Subject: **FCC Class II Permission Change Request for FCC ID: HD5-HAQ**

This is to request a Class II Permission Change Request for FCC ID: HD5-HAQ, originally granted on 2018/05/24.

1. Schematic diagram design change:

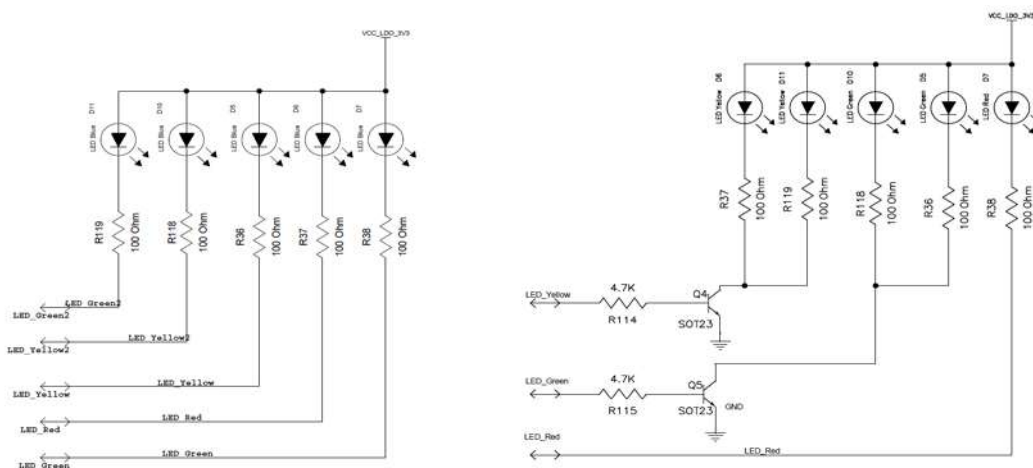
- (1) Add a filter capacitor C1, add a connection (HD) from U16 Pin5 to MCU pin59

2. PCB design change

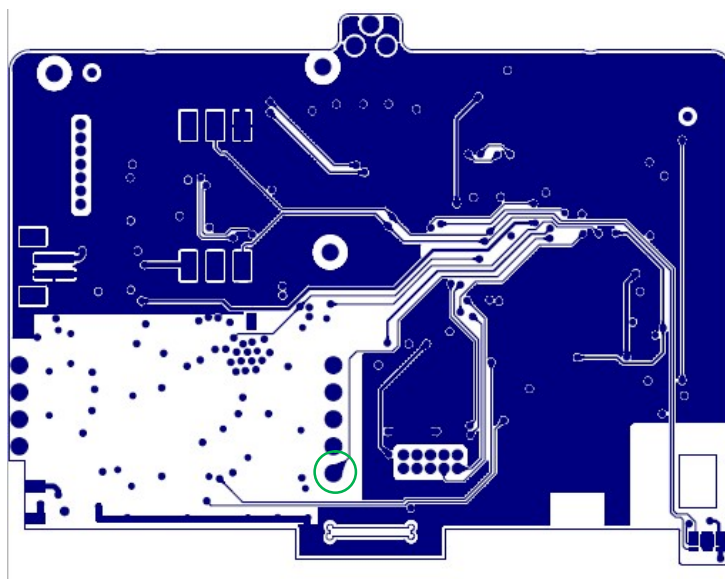
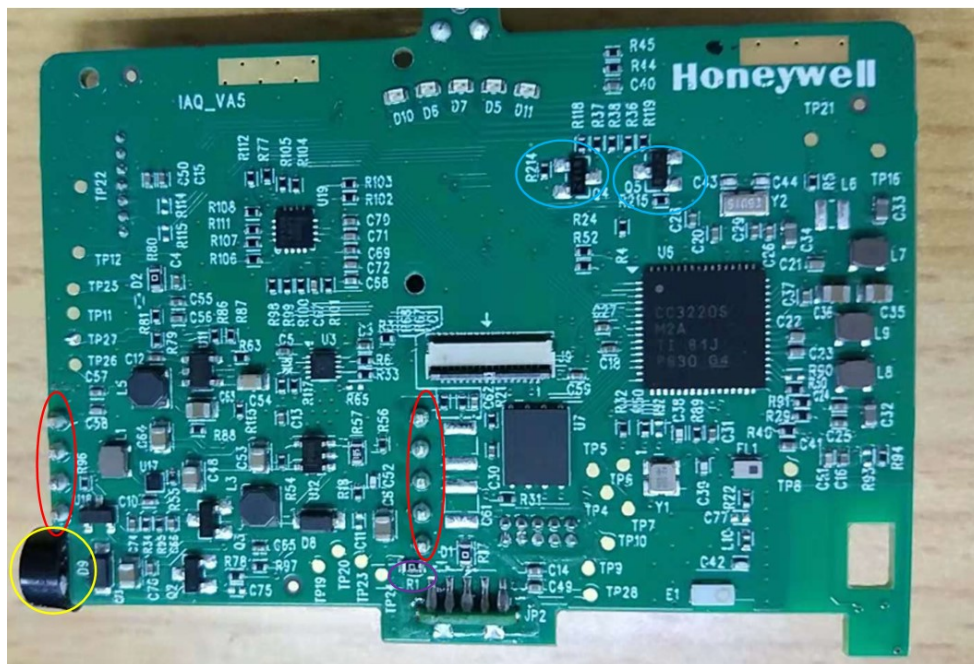
- (1) CO2 sensor (U16) move down 0.7mm, in red circle
- (2) Buzzer JP1 move left 0.6mm, in yellow circle
- (3) R1 move down 0.6mm. in purple circle
- (4) Add resistor R214 and R215, transistor Q4 and Q5, in blue circle
- (5) Add a wire from U16 pin5 to MCU pin59, in green circle
